REDUCED EMISSIONS FORM IMPROVED AND EFFICIENT COOKING IN UGANDAN COMMUNITIES

Report ID	VKU.VER.184.24_VCS_3045
Project title	Reduced Emissions from Improved and Efficient Cooking in Ugandan Communities
Project ID	3045
Verification period	01-August-2022 to 31-December-2023 (Including both the dates)
Original date of issue	30-March-2024
Most recent date of issue	26-July-2024

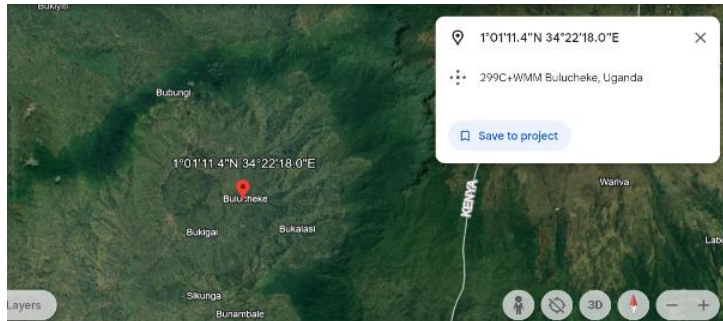
Type	Date	12-March-2024
CAR#02	Reference	ER Sheet
Description of the Non-Conformance		
1. ER Calculation: - The units of parameter B_{old,wood,i,j} and B_{old,charcoal} is inconsistent with the registered PD. - Verification Team found that the given value for ex ante for current monitoring period is not correct as per the registered Joint PDMR. - The value mentioned for ERs achieved during this monitoring period is found to be incorrect. 2. Assumption: PP has not provided reference for the parameters “non-CO₂ emission factor and CO₂ emission factor” in this section of ER sheet. 3. Installation summary: PP has not provided unit of the parameter ‘Model wise age’.		
1stResponse from PP	Date	16-March-2024

1. ER Calculation: - The units of parameter B_{old,wood,i,j} and B_{old,charcoal} is made consistent with the registered PD and the applied methodology.. - As per the registered PD, the Ex-ante ER for 2022 and 2023 are 364,750 tCO₂e and 363,168 tCO₂e respectively. This value is calculated for a complete year. However, the amount estimated ex-ante as mentioned in the ER calculation sheet is calculated for 518 days, duration of the current monitoring period. Kindly refer the demonstration in the ER Calculation sheet. - The ER for this monitoring period has been revised based on the change in value of weighted average for the stove year, replacing the value of simple average for the same parameter. 2. The reference as per the registered Joint PD-MR document, “2006 IPCC Guidelines for National Greenhouse Gas Inventories; Chapter 2 Stationary Combustion”, has been mentioned for the parameters “Non-CO₂ emission factor and CO₂ emission factor” in the Tab” Assumptions” of the updated ER calculation sheet. 3. The unit for the parameter ‘Model wise age’ has been provided in the Installation summary tab of the updated ER Calculation sheet.

1stAssessment by Audit Team	Status	Closed	Date	26-March-2024
1. ER Calculation: - PP has aligned the parameters $B_{old,wood,i,j}$ and $B_{old,charcoal}$ in the revised version of MR with registered VCS joint PD & MR and with applied methodology. Hence the finding the is closed. - It is found that PP has justified the values of ex-ante emission reductions in the ER sheet for current monitoring period. Hence, the finding is now closed, 2. Assumption: PP has provided the relevant references for the parameter “non-CO2 emission factor and CO₂ emission factor” in this section of ER sheet. Hence, the finding is closed. 3. Installation summary: It is found that PP has provided the unit of parameter ‘Model wise age” in the updated version of MR. Hence, the finding is closed.
